# **BRIEFING: MARTIN STREET SHARED USE PATH**

Martin Street between Henderson Avenue and Arcola Avenue

Montgomery County Department of Transportation

Figure 7: Matthew Henson Trail at Georgia Avenue

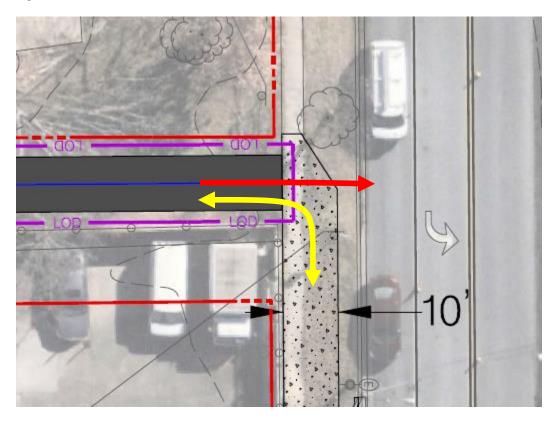
# 2. Consider adding a fence or other vertical element at the southern path terminus to prevent users from unintentionally entering Arcola Avenue.

As currently designed, the southern terminus of the Martin Street Shared Use Path connects to a ten-foot shared use path along Arcola Avenue to allow users to transition to and from the Amherst Avenue Separated Bike Lanes, as indicated by the yellow arrow in Figure 6. Due to existing topography, southbound shared use path users will be traveling downhill as they approach Arcola Avenue and may pick up speed. To reduce the likelihood that users (particularly bicyclists) unintentionally continue straight into Arcola Avenue (red arrow in Figure 6) due to ineffective braking, inattentiveness, etc., the project should include some sort of vertical barrier between the proposed ten-foot Arcola Avenue shared use path and the Arcola Avenue roadway. This barrier would prevent this potentially unsafe situation from occurring. A similar treatment can be seen at the intersection of the Matthew Henson Trail and Georgia Avenue in Aspen Hill (Figure 7), though a more attractive installation would be preferred.
